Los Angeles World Airports (LAWA) has prepared this project-level final environmental impact report (Final EIR) for the South Airfield Improvement Project (SAIP), pursuant to the California Environmental Quality Act (CEQA). The SAIP is a component of the LAX Master Plan Program approved by the Los Angeles City Council in December of 2004. The LAX Master Plan was the subject of a certified, program-level environmental impact report (LAX Master Plan Final EIR) and an approved environmental impact statement (LAX Master Plan Final EIS), which were prepared by LAWA and the Federal Aviation Administration, respectively.

Volume III: Table of Contents

Preface

94 dBA Single Event Noise Effects on Awakenings: Project (2005) Conditions

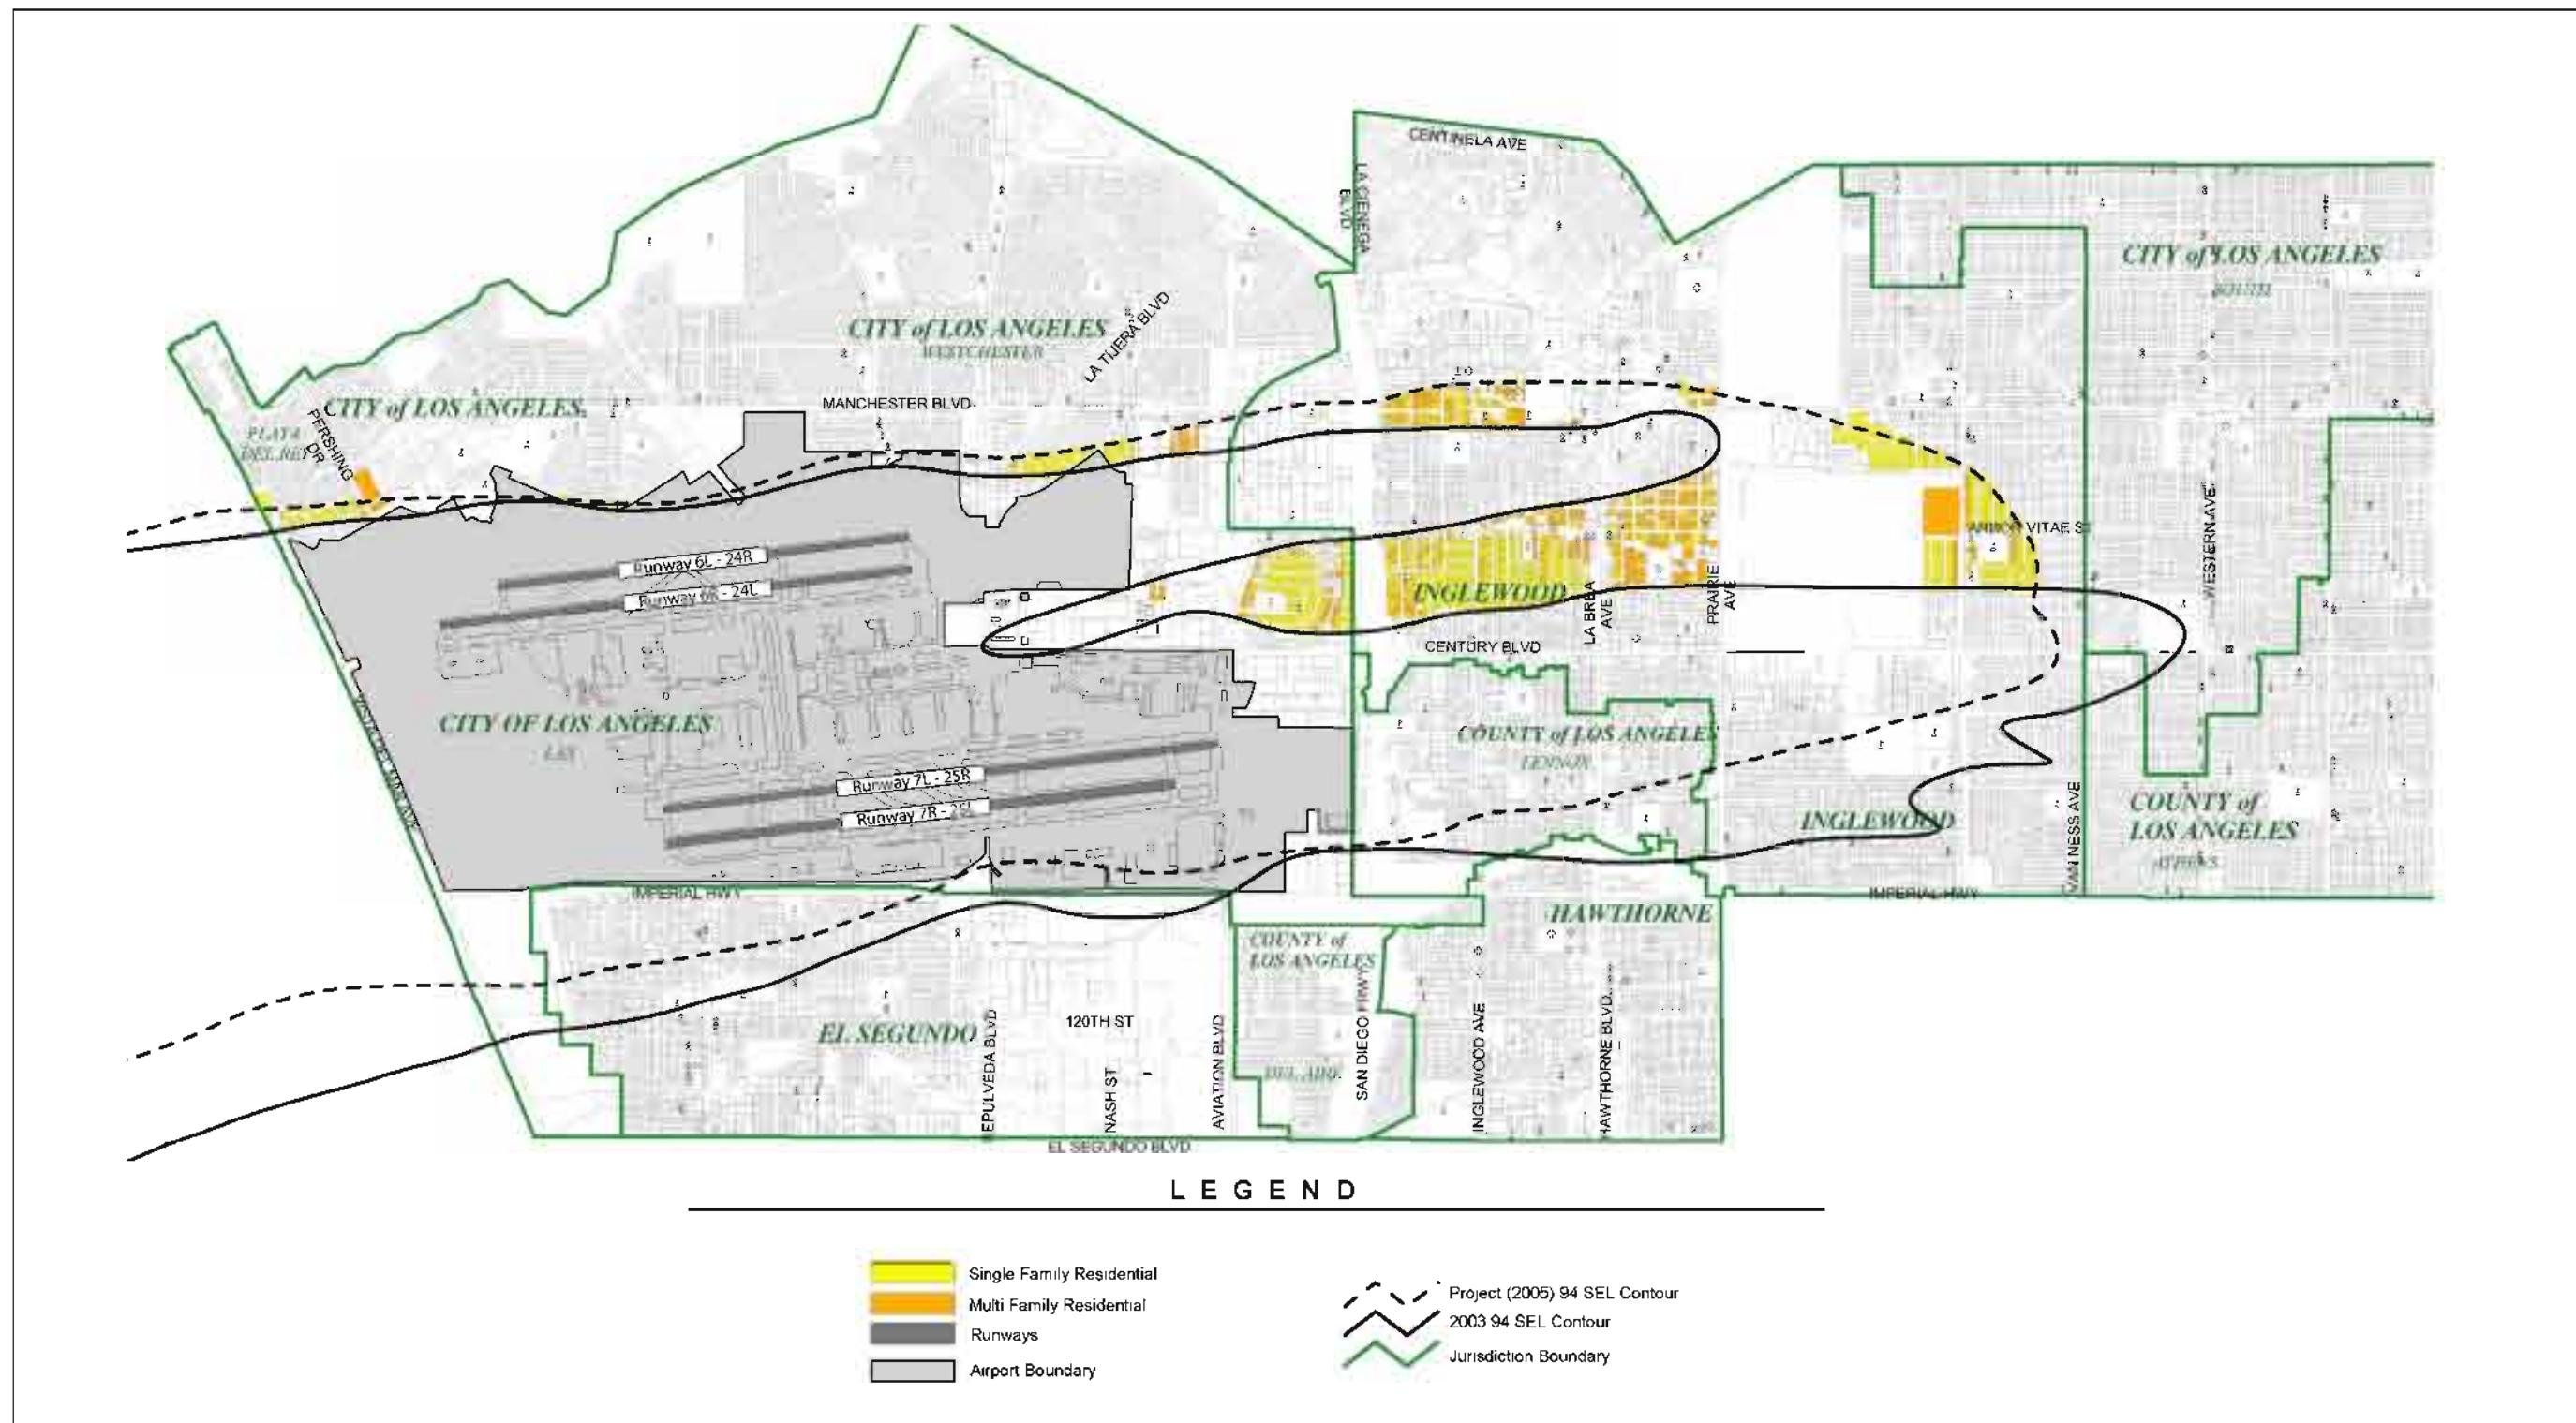
Comment: Exhibit 4.5-7 referred to in discussions regarding Night Awakenings on page IV-167 is generated by a "study" which fails to take into account those residence addresses that actually call into the 64-NOISE phone in disturbance report line. OOPS all those times my address appears on the monthly reports and still I'm not on the map! No wonder my neighbors told me they thought it was a waste of my time. Good golly, I must have spoken to all the field operations staff many who know my voice while I was phoning in my sleep!!!!!!! This exhibit alone stands as evidence that the local community is simply ignored by those with a "money- above- all" mentality!!!!

Assuming the commentor is referring to the 1997 Federal Interagency Committee on Aircraft Noise (FICAN) report on the Effects of Aviation Noise on Awakenings from Sleep, the information provided on Figure 2, Recommended Sleep Disturbance Dose Response Relationship, is still considered the best available science regarding the relationship between nighttime awakenings and aircraft noise. The FICAN curves used to depict the 10 percent awakening threshold is representative of large samples of populations exposed to a variety of awakening situations. Because the FICAN approach was based on statistically reliable evaluations, the noise level associated with the 10 percent awakenings level was selected by the sponsor for its standard for significance.

Figure 1. 24-Hour PM-10 Concentrations ($\mu\text{g}/\text{m}^3$)

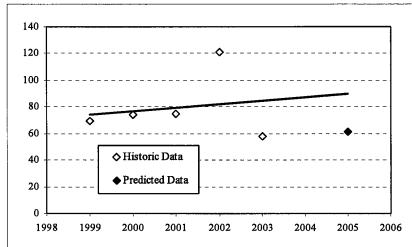
Background PM-2.5 Concentrations: The 24-hour background concentration for PM-2.5 is entirely inconsistent with the assumed 24-hour background concentration for PM-10. It is physically impossible for PM-2.5 concentrations ($83.7 \mu\text{g}/\text{m}^3$) to exceed PM-10 concentrations ($61 \mu\text{g}/\text{m}^3$), the latter includes the former. Either the assumed PM-10 concentration is too low, or the PM-2.5 concentration is too high. If the latter, then the air quality analysis would be conservative for PM-2.5, but it is unclear why such an inconsistency is carried through the DEIR. The DEIR does indicate that the two values are derived from different sources, but it is not clear why PM-2.5 to PM-10 ratios were not used in place of what appear to be absolute PM-2.5 data.

Background Concentrations: Here also, the cited reference letters provide extensive discussion of concerns associated with the use of the linear rollback method to estimate future background concentrations. There are data presented in the DEIR that provide additional insight into the difficulty associated with this approach. For example, the DEIR presents 1999-2003 data for the monitoring station used to estimate LAX background concentrations. Figure 1 presents a summary of that data for 24-hour PM-10 concentrations, selected for illustrative purposes since PM is the pollutant for which the greatest air quality impacts are predicted. As indicated, a simple linear trend of 1999-2003 data indicates a modest uptrend in local PM-10 measurements. However, based on emission reductions expected in central Los Angeles between 2000 and 2005, the DEIR forecasts the 2005 background concentration to be approximately 30 percent below the trend line forecast.

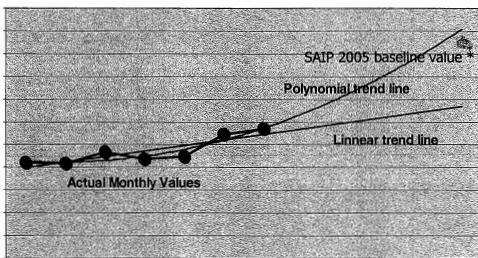
4. **Additional Mitigation Measures:** Although the emission reduction capability of the following mitigation measures may not be easily quantified, the lead agency should consider implementing them wherever feasible.

The attached graph shows that using the first 7 months of aircraft operations the baseline estimate was excessive.

This applies to all environmental estimates. The baseline assumption of aircraft was faulty (high) for the 2005 estimate by a significant amount. This would make all calculations of impacts for subsequent periods appear less significant.
